TOTEM ACOUSTIQUE INC.

## Class II Permissive Change Letter

FCC ID:**2AQ6V-KINAMP**

Please refer to the PCB diagram below.

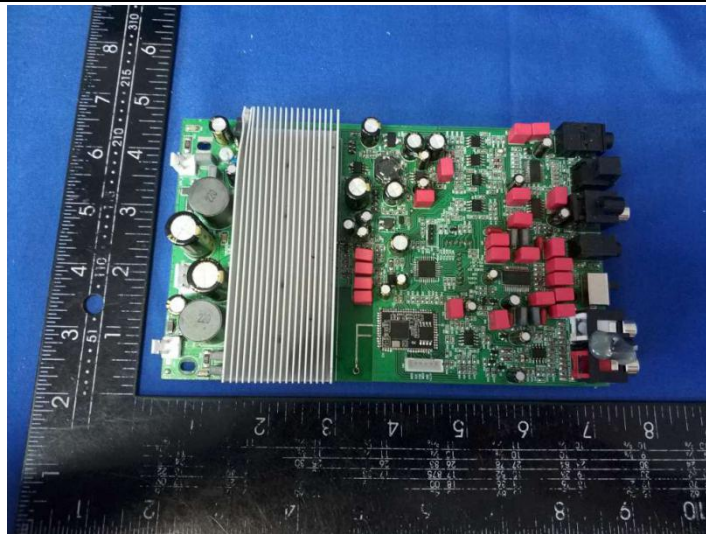
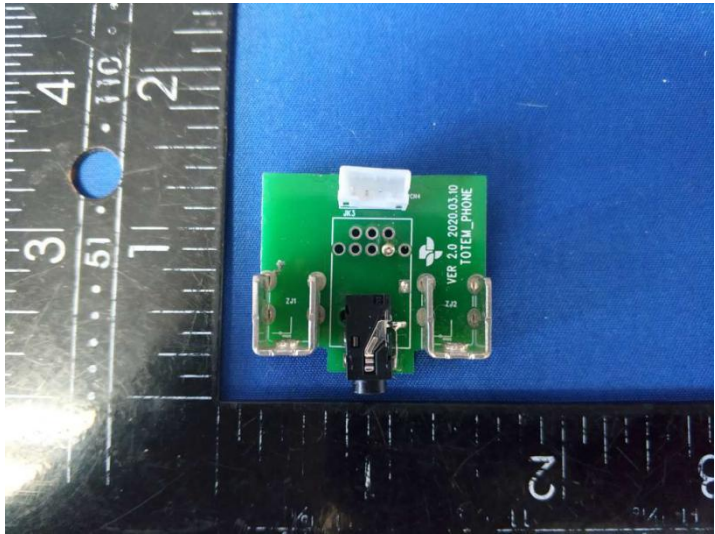
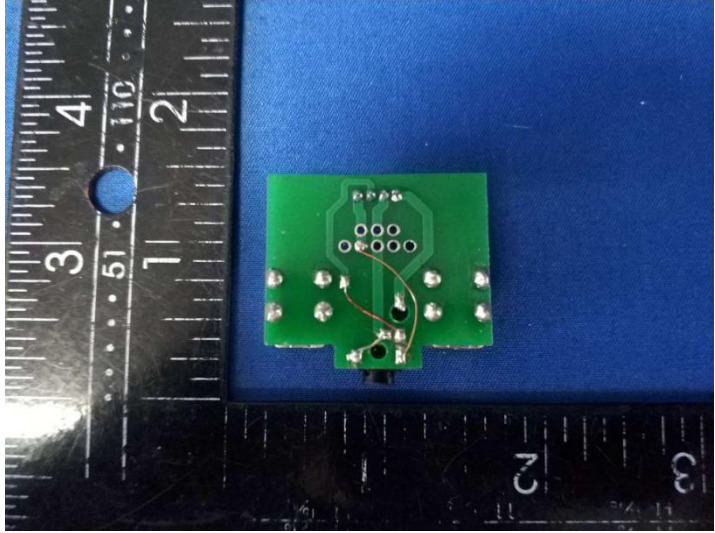
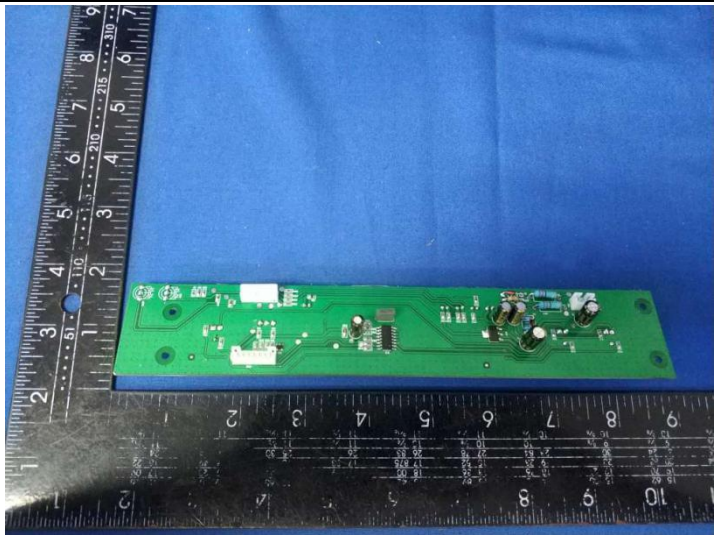
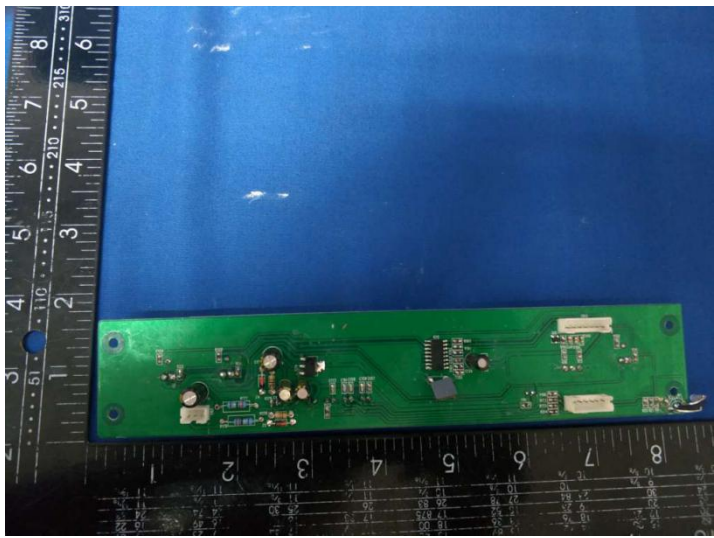
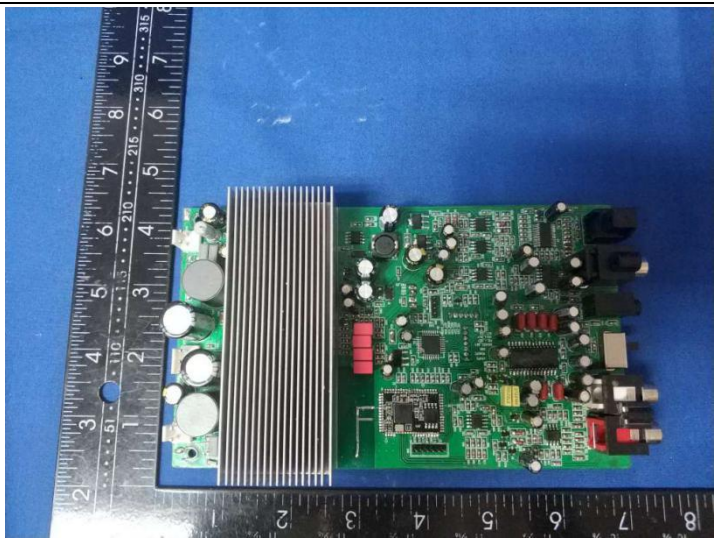
Change 1: **Add input port: "Amp in"**

Change 2: **Add output port: "earphone output"**

Change 3: **IC replacement for MCU, Music DETECT, AUDIO PROCESS, SUB OUT.**
